Amendments to the Drawings:

Type of Response: Amendment
Application Number: 10/559,891
Attorney Docket Number: 324003.07
Filing Date: December 6, 2005

ANNOTATED SHEET SHOWING CHANGES MADE

Figure 4

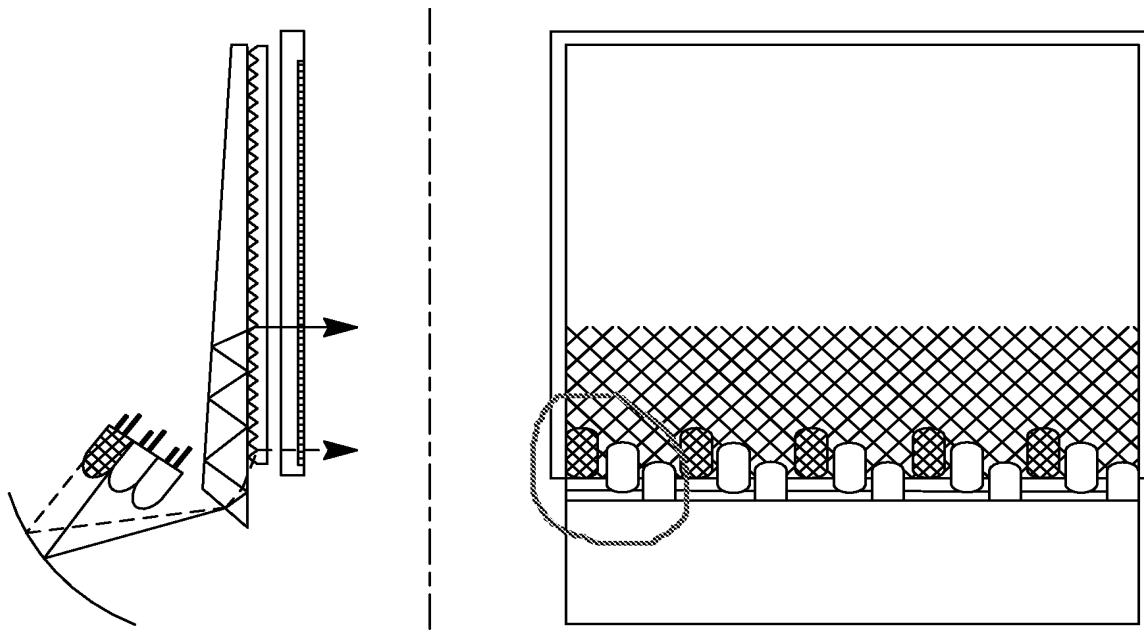
In Figure 4, the top row of LEDs is shown as illuminated in the front view.

The Office Action on page 2 objects to the drawings asserting that Fig. 4 shows the top row of LEDs illuminated in the side view but the bottom row of LEDs illuminated in the front view.

In response to this objection, a replacement sheet of drawings illustrating a revised Fig. 4 has been included. The replacement sheet illustrates Fig. 4 showing the top row (instead of the bottom row) of LEDs illuminated in the front view, which correctly corresponds to the top row of LEDs illuminated in the side view.
